# Tree Removal & Replacement Plan

**Property Address:** 6905 96<sup>th</sup> Ave SE, Mercer Island, WA 98040

**Date:** November 15, 2025

Revision B: March 12, 2026

Figure 2: Approximately Location of Replacement Trees as shown on the Site Plan

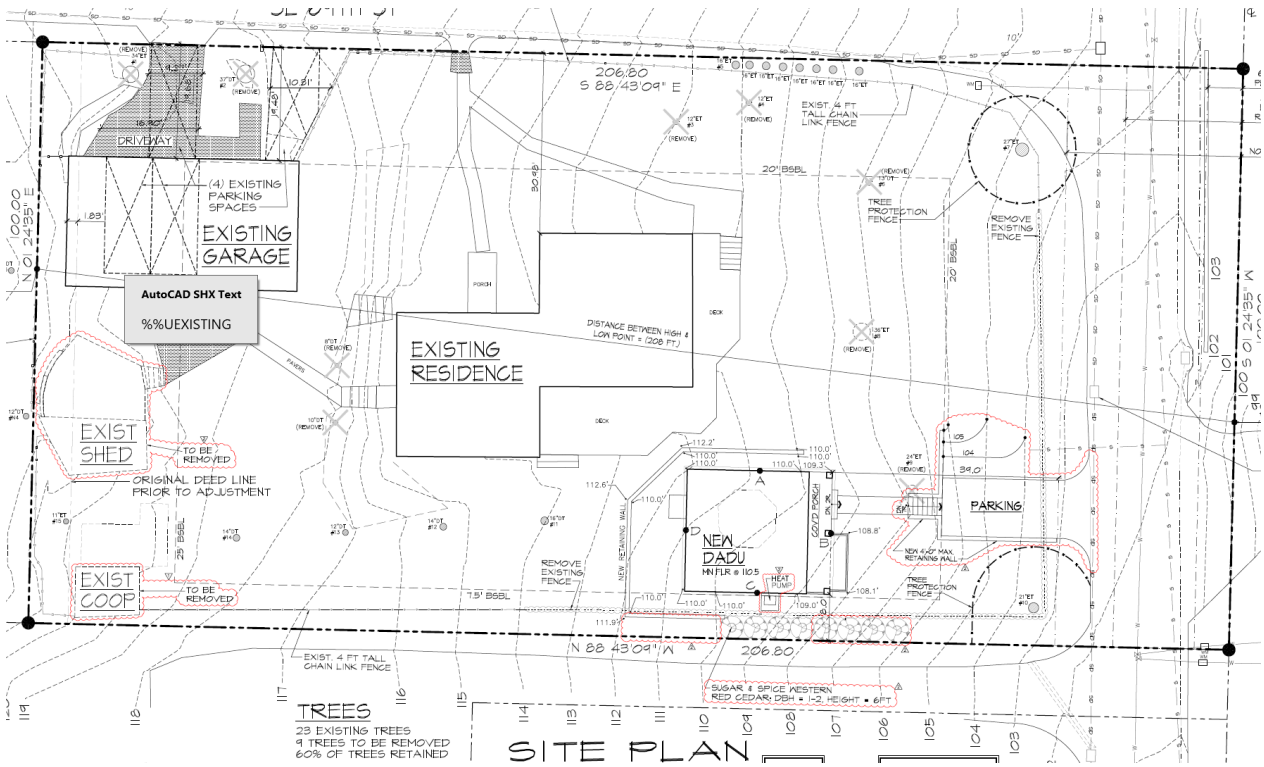
- Update Section 1 to clarify that 10 of 21 trees between 10" and 24".
- Updated Section 3 to change the replacement trees from emerald green arborvitae trees to sugar and spice western red cedar tree.
- Update Figure 2 to reflect the approximate location of the replacement trees on Site Plan (Sheet A0) to better match with the location shown on the arborist report submitted.

As indicated in the arborist report and on the site plan, a row of 8 sugar and spice western red cedar trees (conifers) at least six feet tall will be planted as replacement trees south of the proposed ADU as shown in Figure 1 and Figure 2 below.
